# TOWN OF PLAINFIELD DESIGN REVIEW REPORT

DATE: 06-08-2023  
CASE NO.: [Not Docketed](#)  
PETITIONER: Evo Development  
REQUESTED ACTIONS: Architectural and Site Design Review for a proposed drive through restaurant  
LOCATION: 405 South Perry Road  
PARCEL SIZE: 1.3 acres+/-

The applicant is seeking Development Plan approval for a Cousins Subs drive-through restaurant. The proposed plan includes a 2,400 sq.ft. building, drive-through facilities, patio area, 25 off-street parking spaces, and other site improvements.

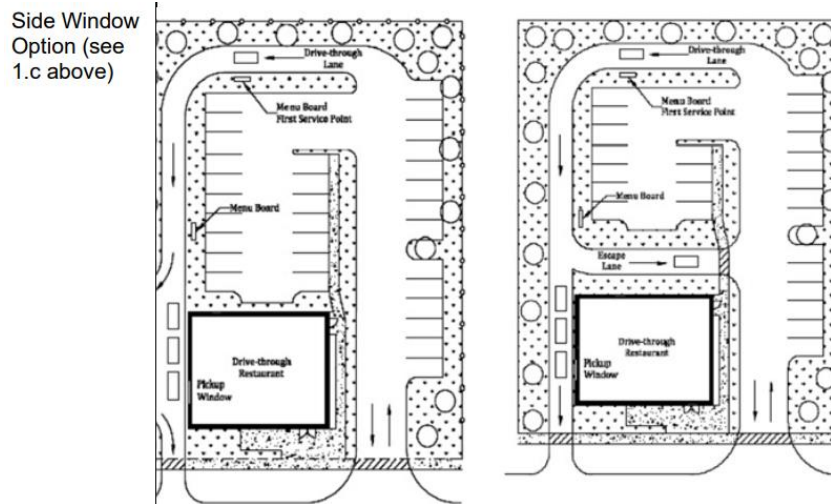
As noted above, the site is within an existing commercial subdivision which has a platted 30' Utility and Drainage Easement. The easement would prevent the building from being 20' from the west property line. The applicant's proposed layout shows the building being located approximately 100' from the Perry Rd.

right-of-way. The excessive distance appears to be necessitated by operational requirements of the drive-through which includes a waiting area located beyond the window.

The proposed drive through includes a pickup window on the side of the building and this design *may* be approved by the Plan Commission. Staff would note that the side window option was intended to offer flexibility in building design while still maintaining a building-forward site layout.
